CONSTRUCTION SUMMARY

Kingsmen (Thames) Inc. / Havelock Corners (Kingsmen)

Lot/Unit: 3 Phase/Building: 4A Model/Floor Plan: Louis (4203) Elev A 4 Bed - 4+1 Bath

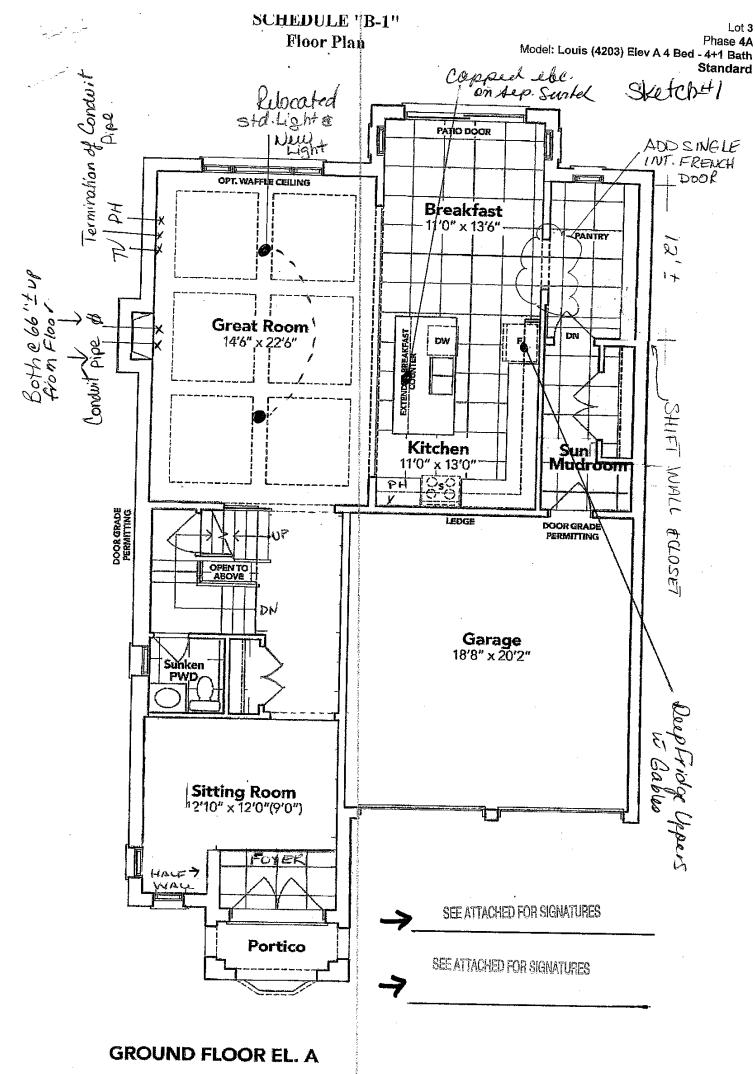
Inv. 4646	1 - To supply & install the standard T.V. rough in the great room and master bedroom see sketch # 1 & # 2	
Line 59529	Note:	
20May20 / 15Jun20		
Inv. 4646	1 - To supply & install the standard Phone rough in in the kitchen, great room and master bedroomsee sketch # 1 & # 2	
Line 59530	Note:	
20May20 / 15Jun20		
Inv. 4646	1 - To SUPPLY AND INSTALL AN ADDITIONAL BASIC RECEPTACLE (NOT DEDICATED) at approx. 66" + - up from the floor centered + - to the F/P mantle	
Line 59531	Note: in the great room see sketch # 1	
20May20 / 15Jun20	This is for a future wall mount t.v.	
Inv. 4646	1 - To SUPPLY AND INSTALL CONDUIT FOR TV OVER THE FIREPLACE – TERMINATED IN SAME ROOM have it installed at approx. 66 " + - up from the floor centered + - to the F/P mantle and terminated next to +- the standard T.V.rough in in the great roomsee sketch #1	
Line 59532	Note: This is for a future wall mount t.v.	
20May20 / 15Jun20

Inv. 4646	1 - To SUPPLY AND INSTALL EXTRA CEILING BOX ROUGH IN CAPPED (DOES NOT INCLUDE SWITCH) over the Breakfast bar in the kitchensee sketch # 1	
Line 59535	Note: This ceiling capped elec. will be connected to a sep. switch, switch is sold sep.	
20May20 / 15Jun20		
Inv. 4646	1 - To supply & install AN ADDITIONAL SINGLE POLE SWITCH connected to the upgraded ceiling capped elec. over the breakfast bar in the kitchen.	
Line 59536	Note:	
20May20 / 15Jun20		
Inv. 4646	1 - Relocate the standard ceiling light in the great room see sketch # 1	
Line 59537	Note:	
20May20 / 15Jun20		
Inv. 4646	1 - To supply & install a second light in the great room (rough in included) see sketch # 1	
Line 59538	Note: This second light will be connected to the standard relocated light in the great roomboth on the same standard switch.	
20May20 / 15Jun20

Inv. 4672	1 - See revised sketch # 1 for direction of the pantry door swing off the breakfast area.	
Line 59797	Note: This item was purchased on extra no: 7 dated June 15, 2020	
16Jun20 / 16Jun20		
Inv. 4646	1 - To supply & install the standard hardwood to the main floor hallway area in lieu of the standard ceramine floor tile. This was missed on the Schedule "PE", was sketched out on main floor plan.	
Line 59525	Note: (same standard hardwood type as noted on schedule "A") This has been approved by Head Office.	
20May20 / 15Jun20		
Inv. 4646	1 - Reduce size of mud room, shift the standard closet in the mud room towards garage, increase the length of the walk in pantry area to approx. 12 feet in length + -; to supply & install a french door to the pantry area see sketch # 1	
Line 59526	Note: Mud room will still remain as a sunkin area. (step(s)) to grade	
20May20 / 15Jun20

SECOND FLOOR EL. A

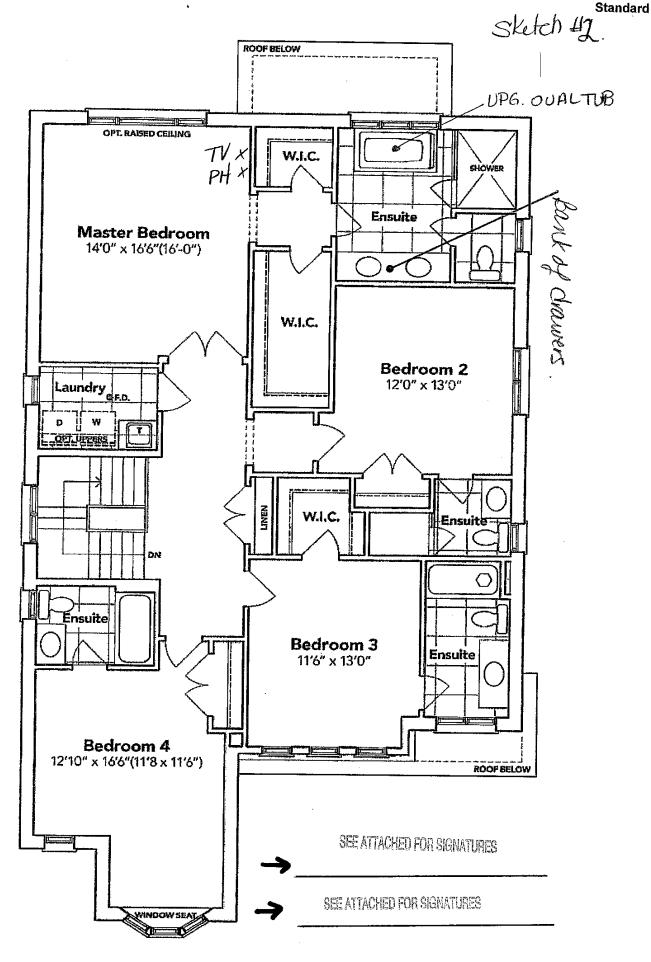
Inv. 4646	1 - To supply & install a VANITY BANK OF DRAWERS - MAX. WIDTH 55CM - CLASSIC SERIES in the master ensuitesee sketch # 2	
Line 59544	Note:	
20May20 / 15Jun20

Inv. 4646	1 - To supply & install the MIROLIN "BROOKE" free standing tub in the master ensuite in lieu of the standard free standing tub see spec's.	
Line 59528	Note:	
20May20 / 15Jun20		
RAILING		
Inv. 4646	1 - As per schedule "PE": Vendor to include wroght iron pickets throughout in lieu of included wood pickets as per plan. This has no cash value. To be selected from builders standards.	
Line 59524	Note:	
20May20 / 15Jun20
